# Access Compliance Report

## Public Rights-of-Way

### (Curb Ramps)

Intersection ID: 45757	Main Street: MOSS_GLEN_CT	Cross Street: GRANDEUR_RD	Location: NW
ADA ID: 6443EED309B8	Ramp Type: Perp	Initial Pass/Fail: Fail	Overall Compliance: No
Codes/Mitigation Info/Possible Solution		Field Measurements/Component Compliance

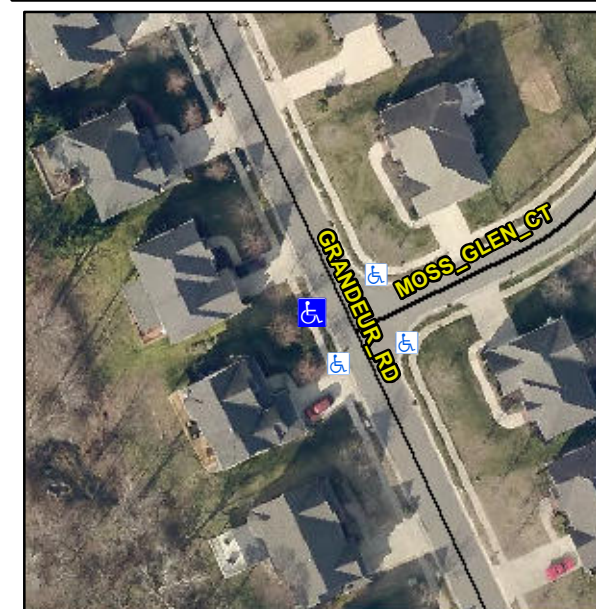
**Not Found, R304.5.1, R304.5.3**

Compliance	Description	Data	Compliance	Description	Data
N/A	Ramp Length (in)	49.0	Yes	Ramp Slope (%)	7.3
No	Ramp Width (in)	47.0	No	Ramp XSlope (%)	3.3
N/A	Flare Type LT	N/A	N/A	Flare Type RT	N/A
N/A	Flare Slope LT (%)	N/A	N/A	Flare Slope RT (%)	N/A
N/A	Flare Traversable LT?	N/A	N/A	Flare Traversable RT?	N/A
N/A	Landing Length (in)	N/A	N/A	DWS Provided?	N/A
N/A	Landing Width (in)	N/A	N/A	DWS Contrast?	N/A
N/A	Landing Slope (%)	N/A	N/A	DWS Length (in)	N/A
N/A	Landing X Slope (%)	N/A	N/A	DWS Full Width?	N/A
N/A	Landing Curb? (Y/N)	N/A	N/A	DWS Offset (in)	N/A
N/A	Shared Landing?	N/A			
N/A	Gutter Ponding?	N/A	N/A	Gutter Slope (%)	N/A
N/A	Gutter Lip Ht (in)	N/A	N/A	Gutter X Slope (%)	N/A
N/A	Painted X Walk1?	No	N/A	Painted X Walk2?	N/A
	X Walk 1 Direction	To E		X Walk 2 Direction	N/A
N/A	X Walk 1 Width (in)	N/A	N/A	X Walk 2 Width (in)	N/A
	X Walk 1 Slope (%)	4.9		X Walk 2 Slope (%)	N/A
	X Walk 1 X Slope (%)	2.7		X Walk 2 X Slope (%)	N/A

**Remove & Replace Entire Ramp.**
